Reduce the existing building area to include a two tenant space and remove 1 parking space.

Re: Agent Authorization Notice – 2100 Louisiana Blvd. NE (Winrock Town Center)

RE: 1002202 - WINROCK TOWN CENTER - BLVD. NE – ALBUQUERQUE, NM 87110 – ADMINISTRATIVE AMENDMENT TO EXISTING PAD SITE AND ELEVATIONS

GRADING & DRAINAGE PLAN

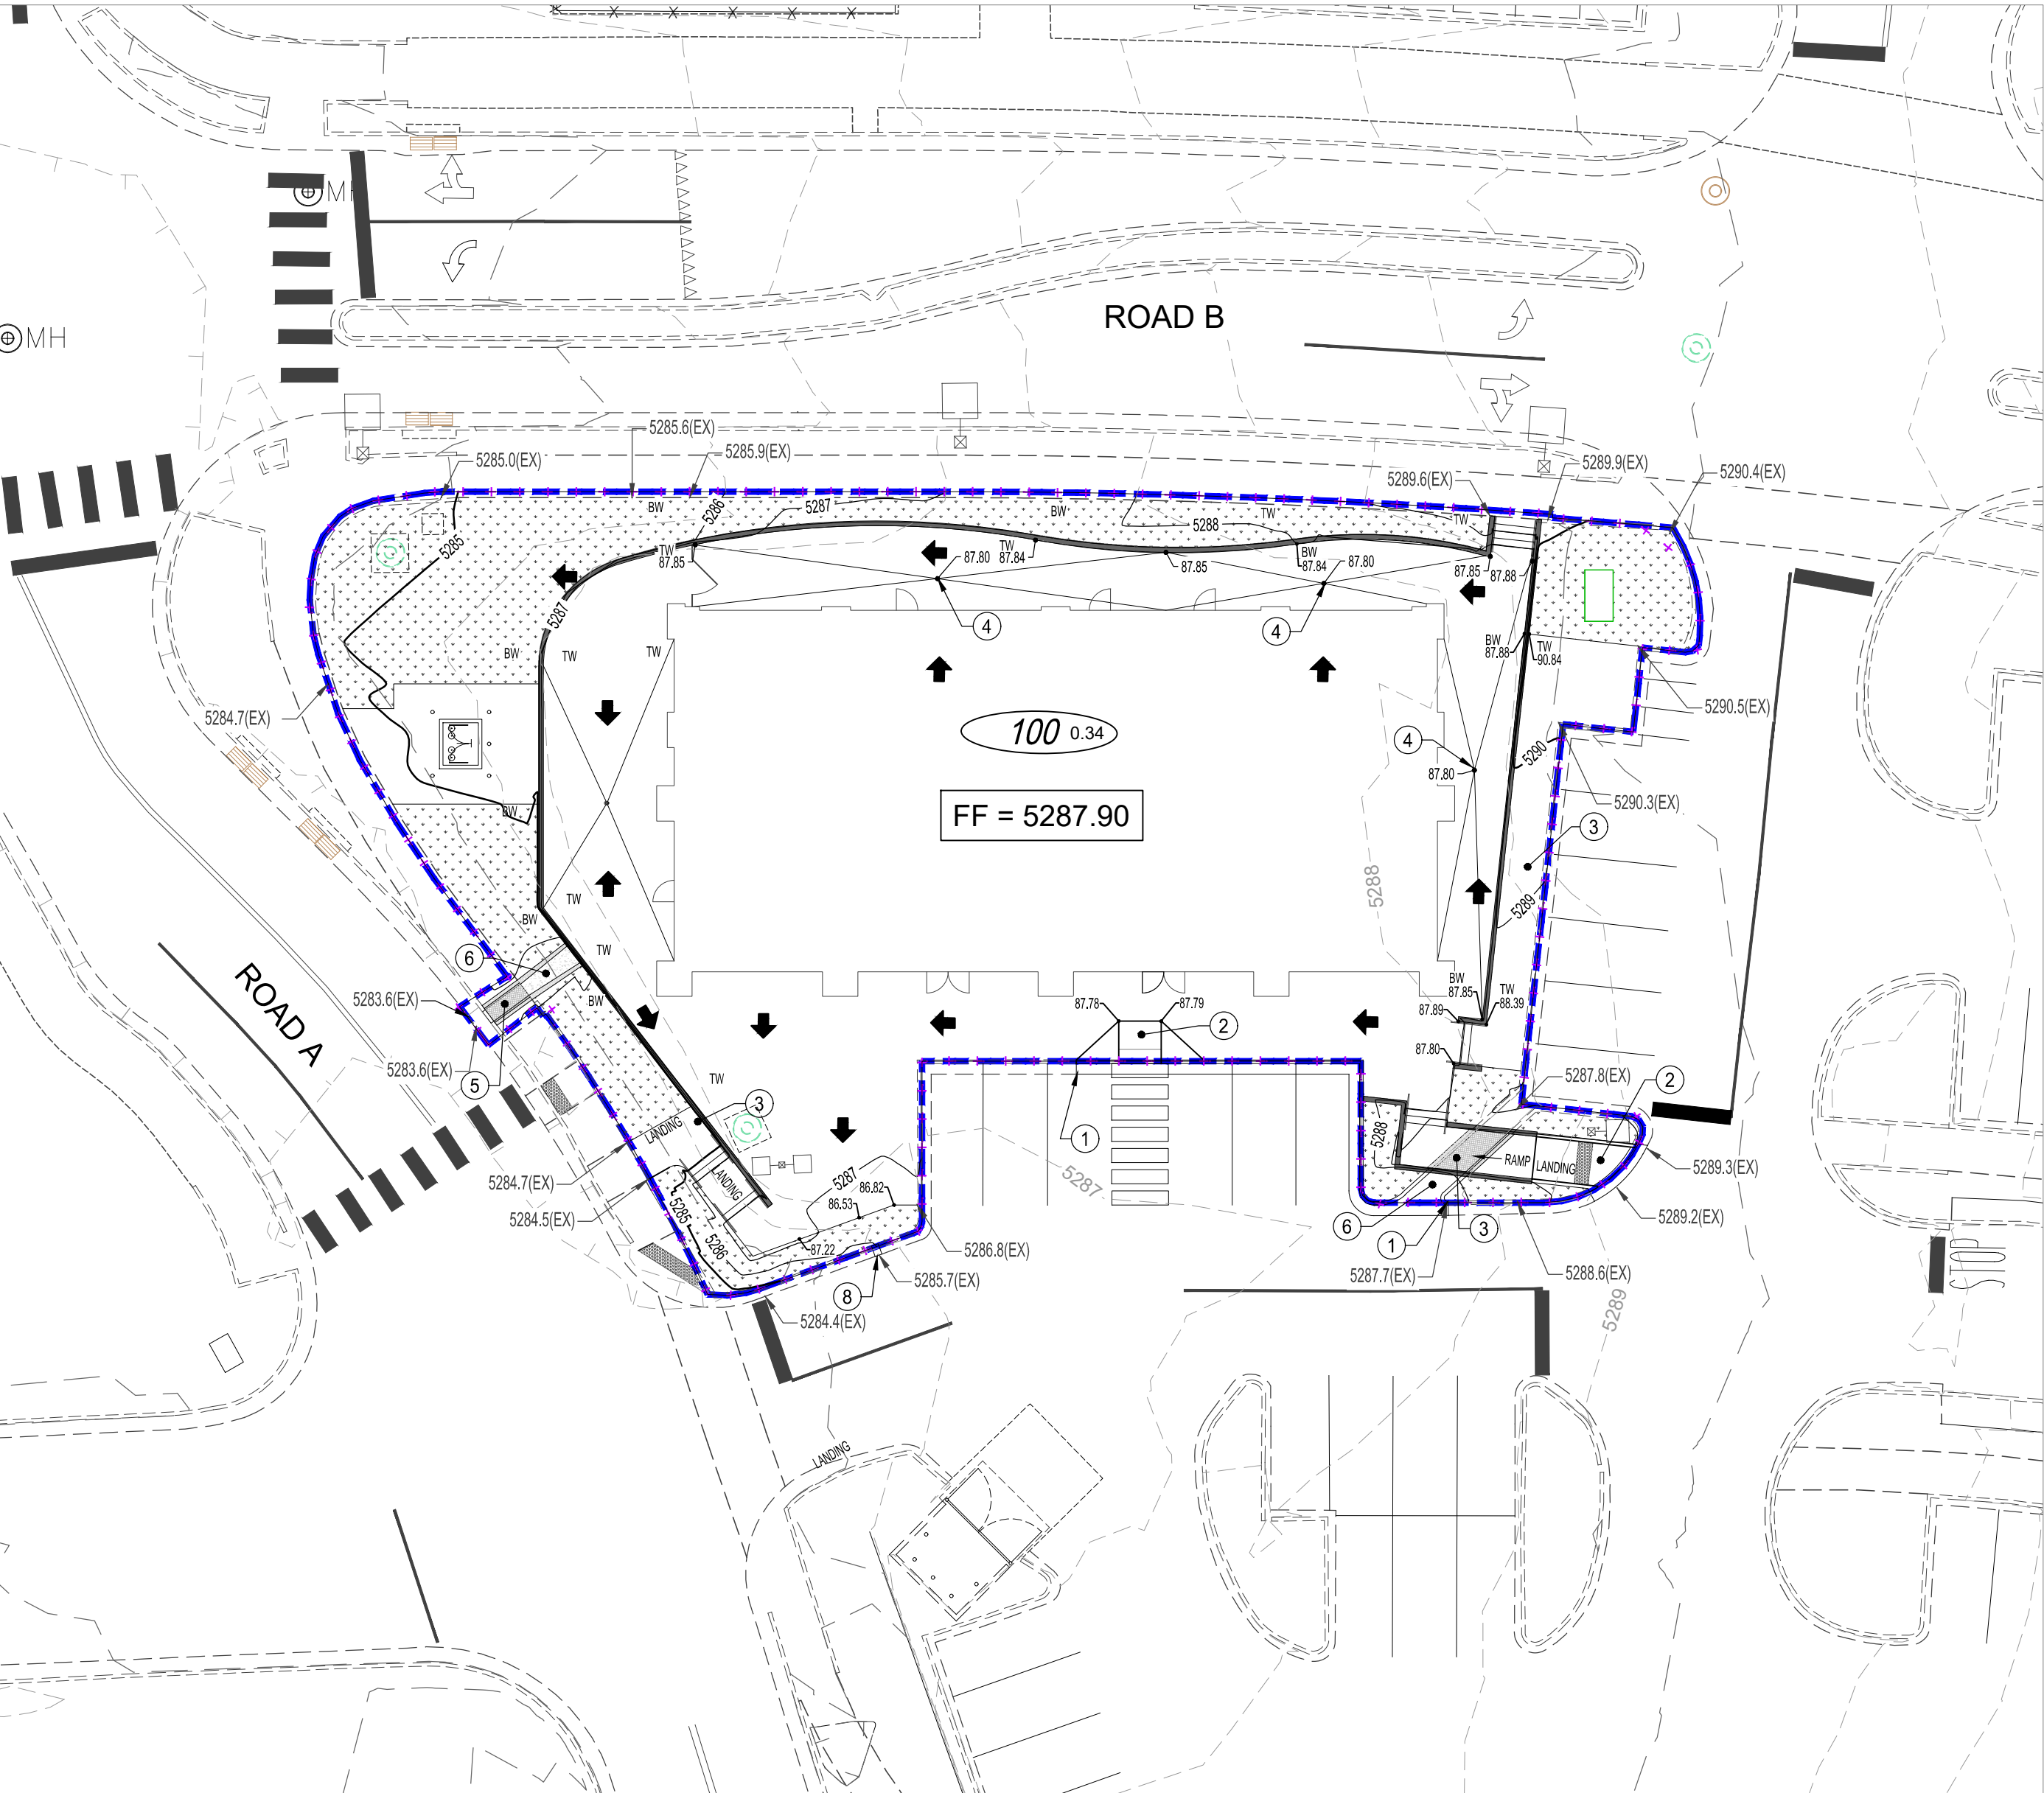
- Grading plan reflects proposed changes and has been submitted to the hydrology department for a review and approval.

Landscape
Plan

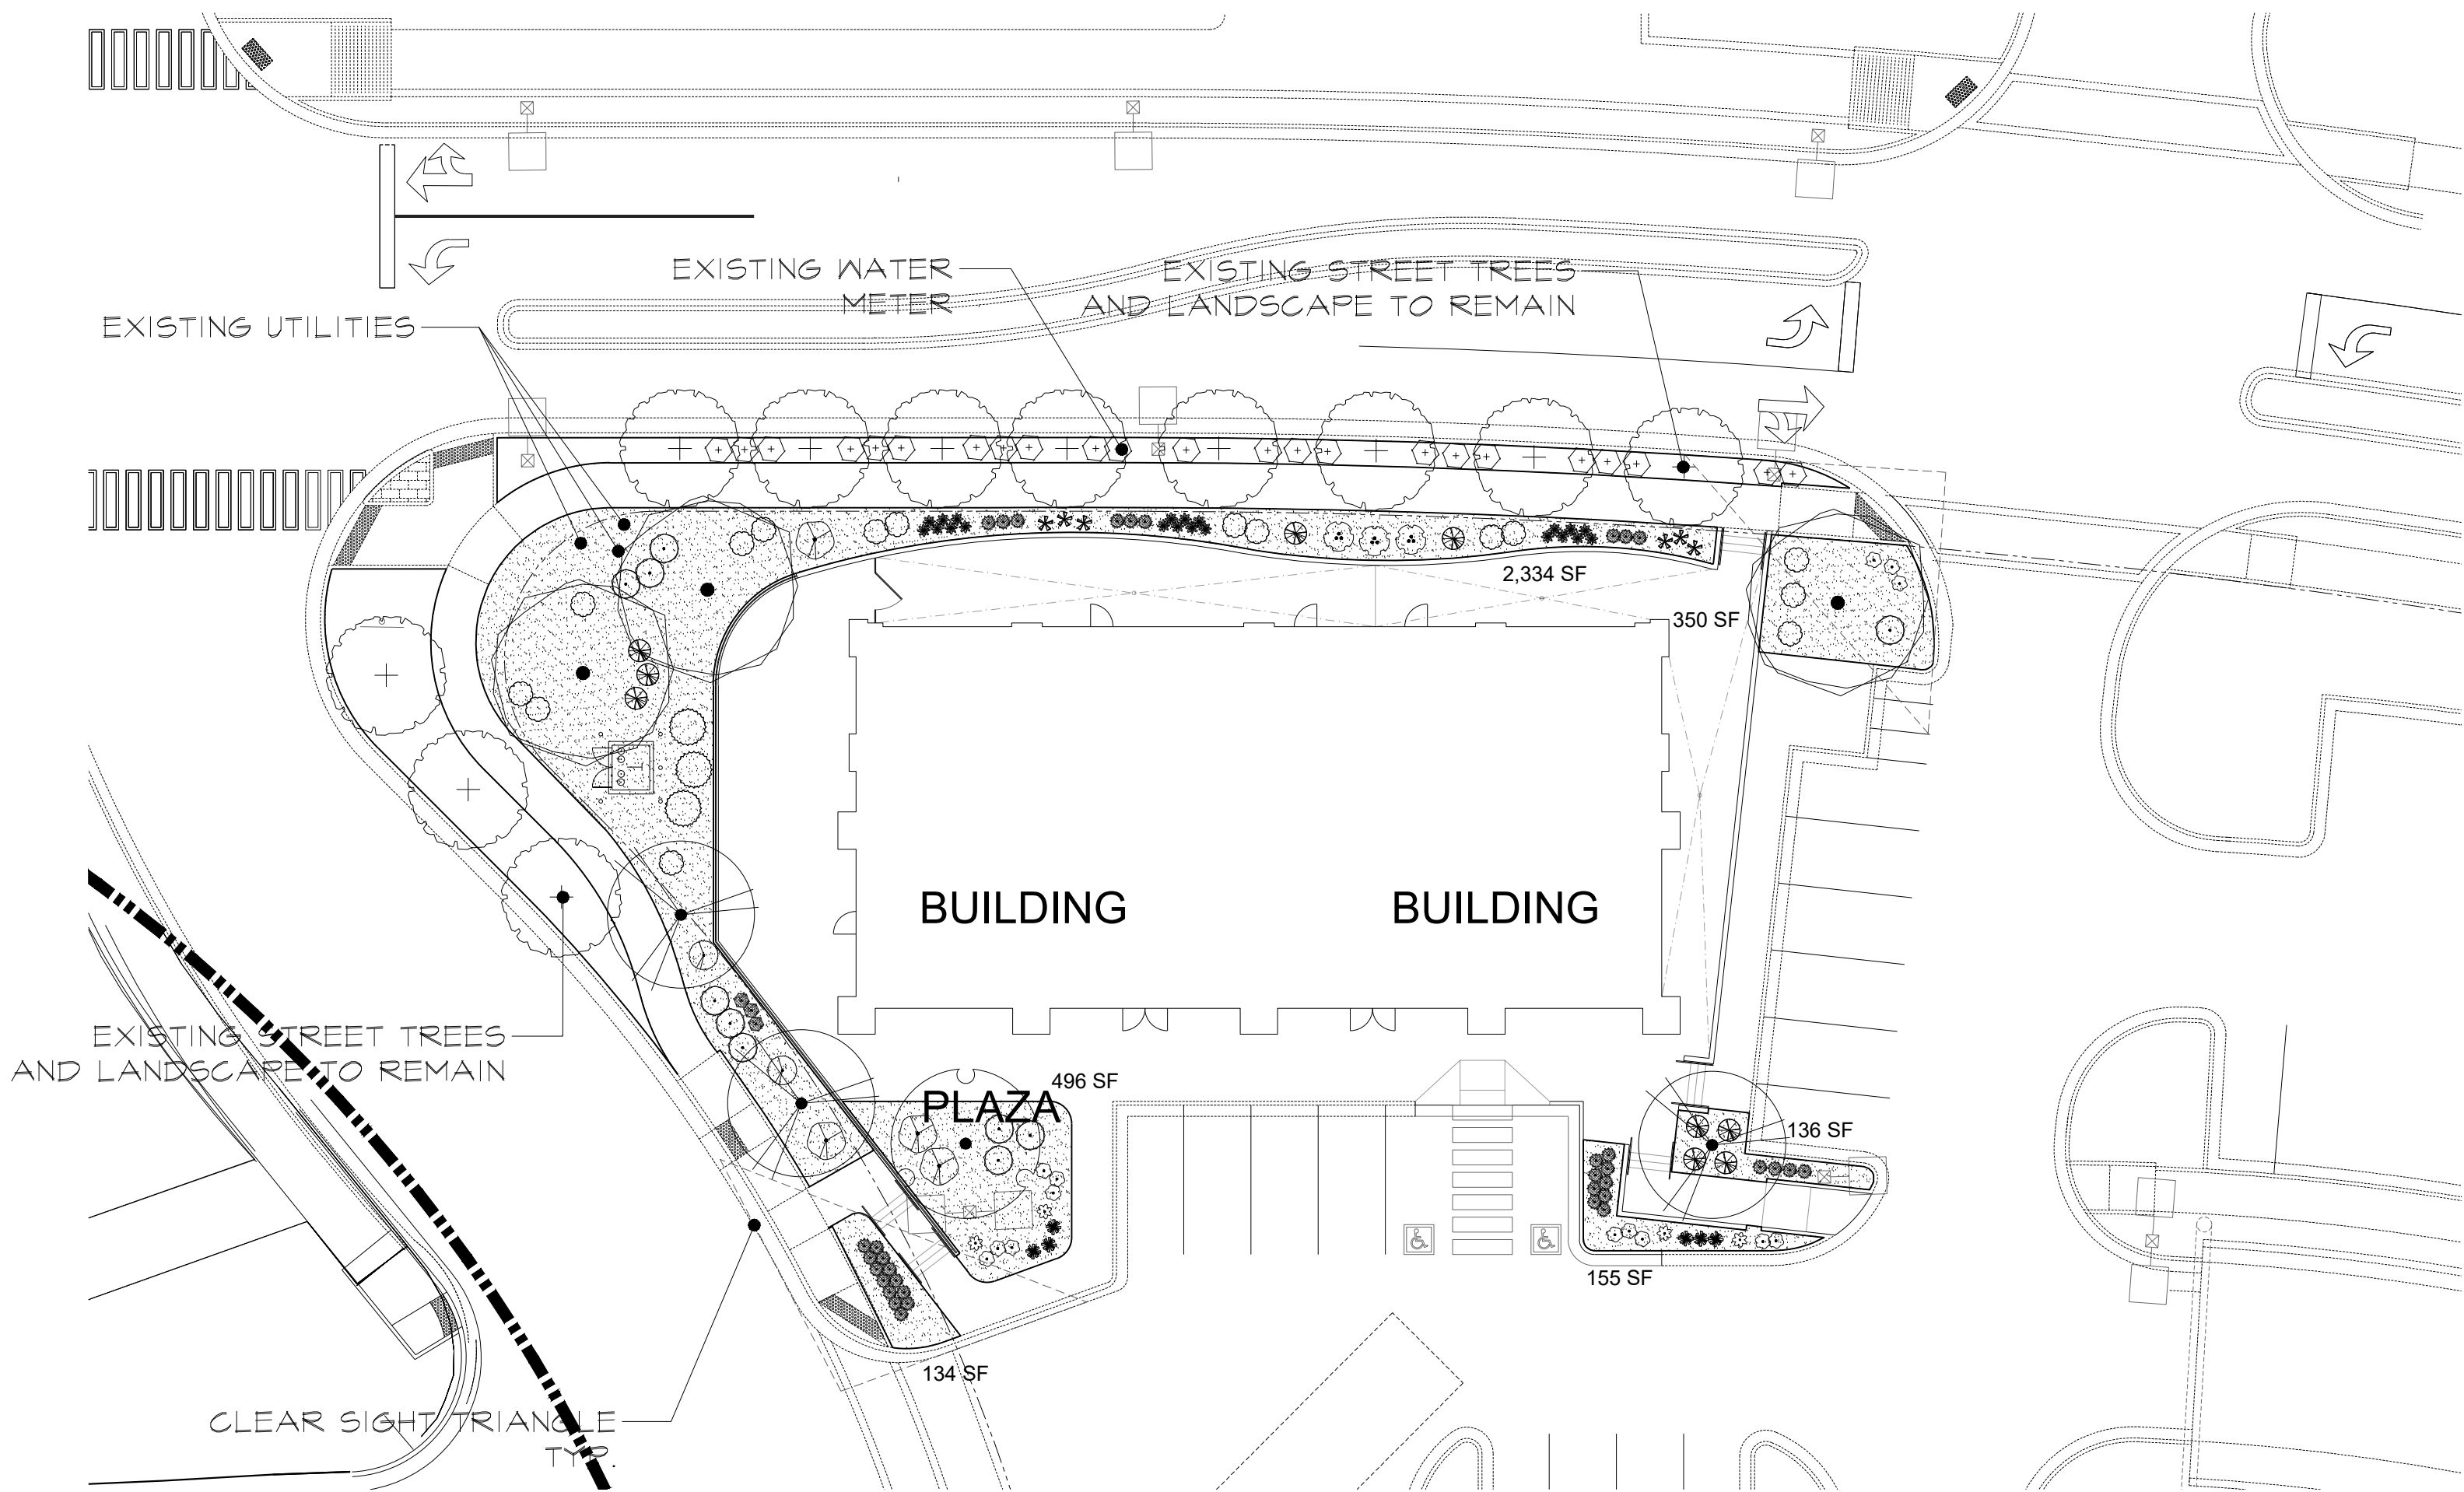
- The landscaping plan shows the new proposed landscaping areas and proposed vegetation.
